## DRAINAGE AND TRANSPORTATION INFORMATION SHEET

ENGINEER'S SEAL	LOT 8-A RAYNOLD ADDITION	DRAWN BY JDC
	GRADING AND DRAINAGE PLAN	DATE 05-20-2015
5/27/15	 <div style="text-align: center;"> <i>Rio Grande Engineering</i>          1606 CENTRAL AVENUE SE          SUITE 207          ALBUQUERQUE, NM 87106          (505) 872-0989       </div>	SHEET #  1 OF 1
DAVID SOULE P.E. #14522		JOB #

**RE: Raynold Addition  
Lot 7-A And 8-A Coal Ave NW  
Grading and Drainage Plan  
Engineers Stamp Date 5/27/14 (K13D73)**

Based upon the information provided in your submittal received 5/27/15, this plan cannot be approved for Grading Permit and Building Permit until the following comments are addressed.

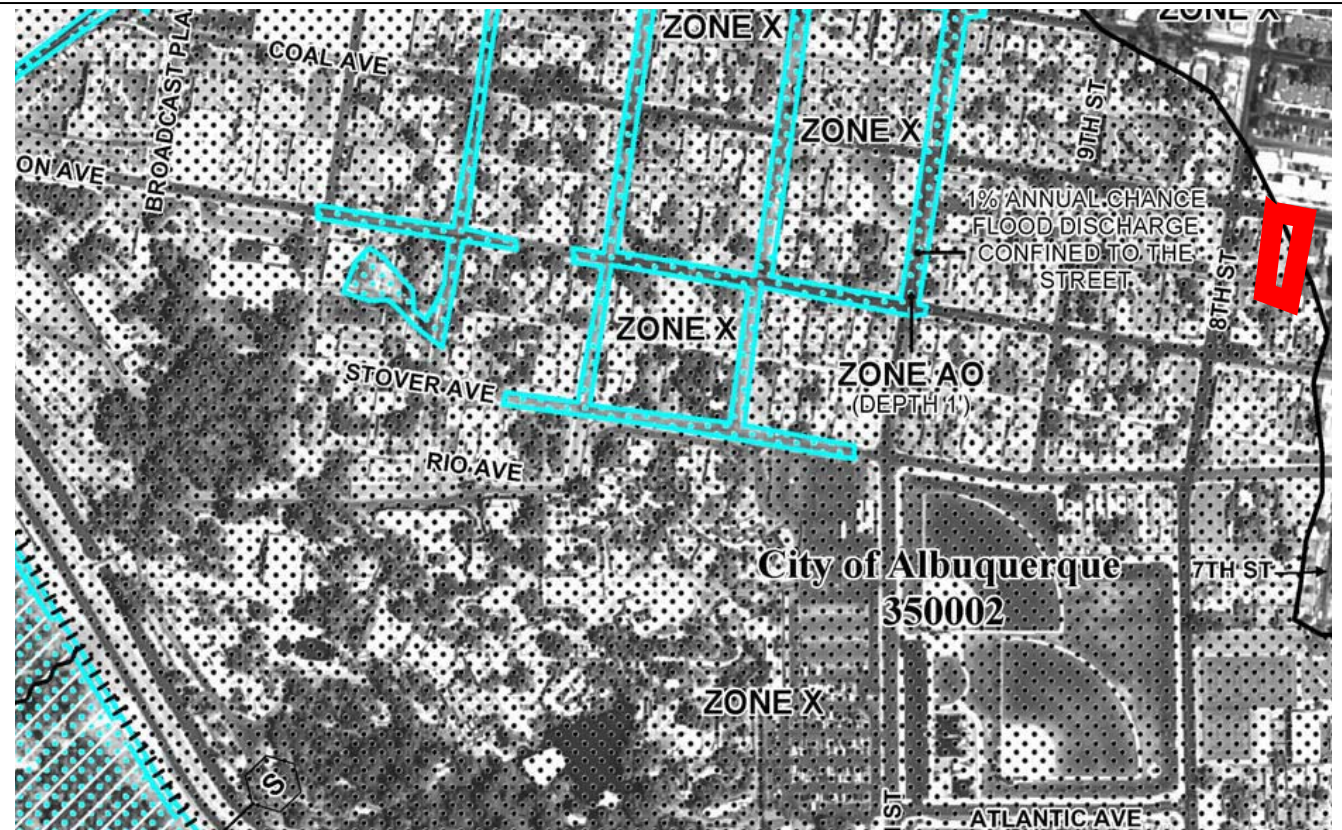
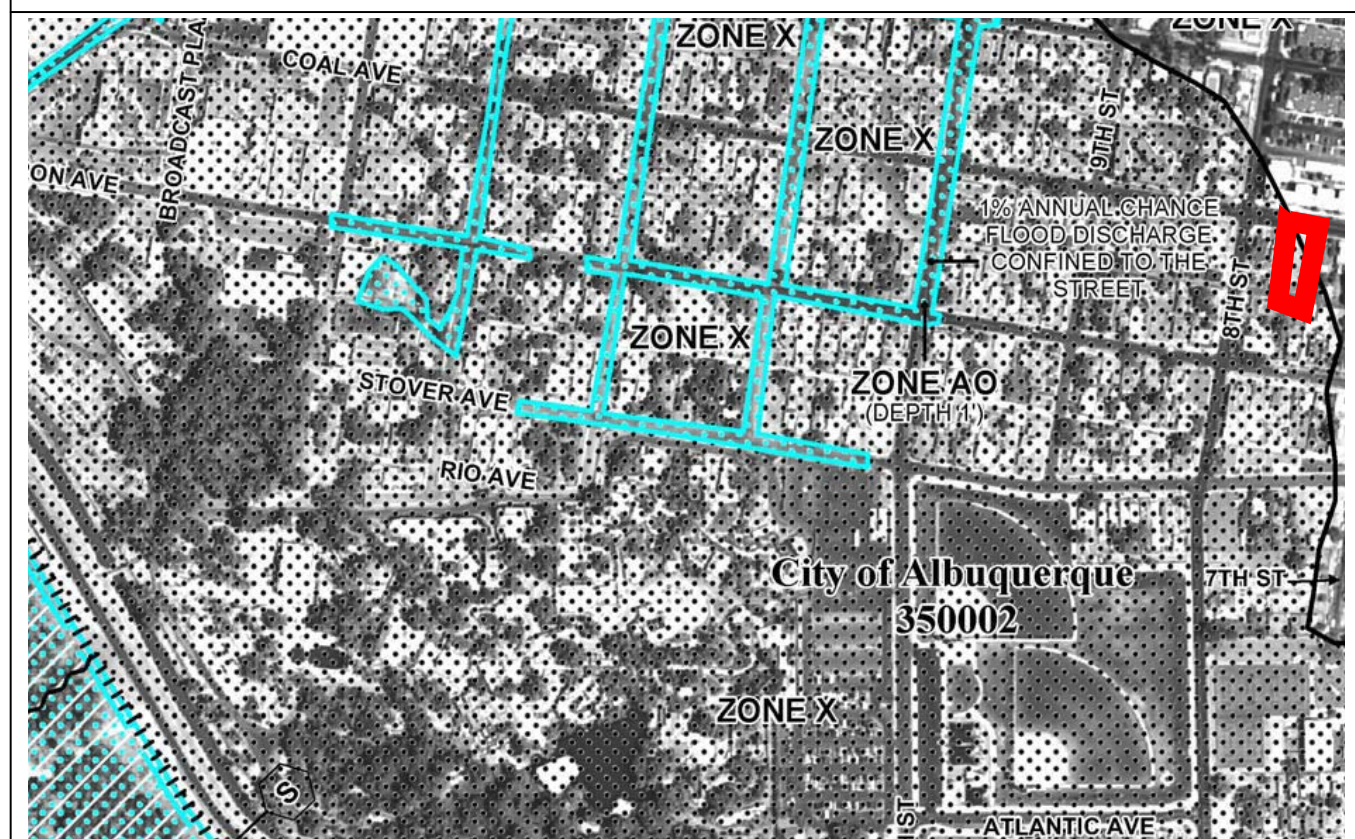
- Provide build notes on the G&D plan.
- Provide duplexes on one sheet or provide two different submittals.
- Provide a narrative or build notes for the duplexes.
- Provide existing and proposed contours.
- Provide roof flows. We want to make sure all flows are directed away from the homes.
- Provide the purpose of the perforated pipe in the swale. Are roof drains connected to this pipe?
- How are the flows leaving the site/s? Are flows entering the site from the alley?
- Show that the requirement of retaining the first 6hr storm or the 2.75 cfs/acre is being met for the valley.
